Subject: UNUSUAL NOISE WHEN STARTING TO MOVE VEHICLE WHILE STEERING WHEEL IS TURNED TO FULL LEFT POSITION	Bulletin No: 06-001/15
	Last Issued: 07/21/2015

- This bulletin supersedes the previous bulletin 06-002/14, issued on 07/29/14 and 06-002/13, issued on 10/09/13. The APPLICABLE MODEL(S)/VINS, DESCRIPTION, REPAIR PROCEDURE, PART(S) and WARRANTY INFORMATION have been revised.
- Changes are noted below in Red beside the change bar.

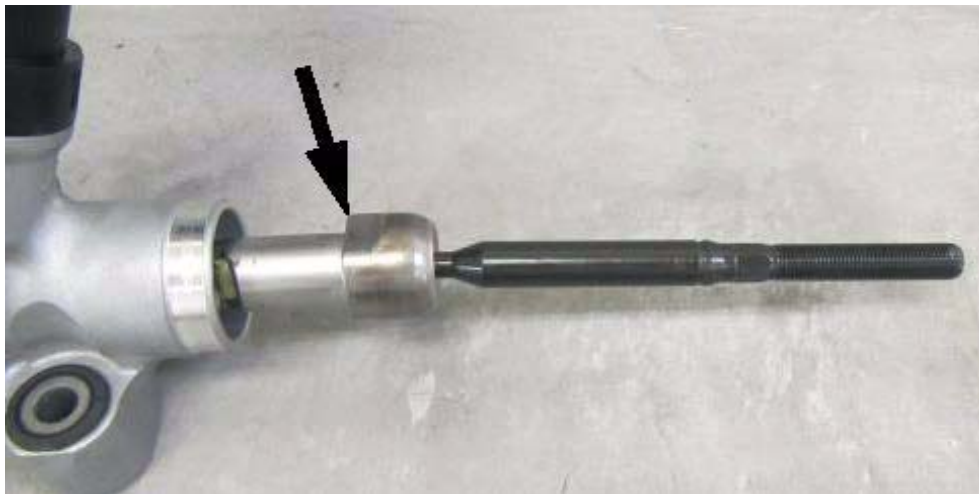
The noise is caused when the edge of the left side inner ball joint gets stuck with the steering gear housing.

To eliminate the noise, the shape of the inner ball joint edge has been changed.
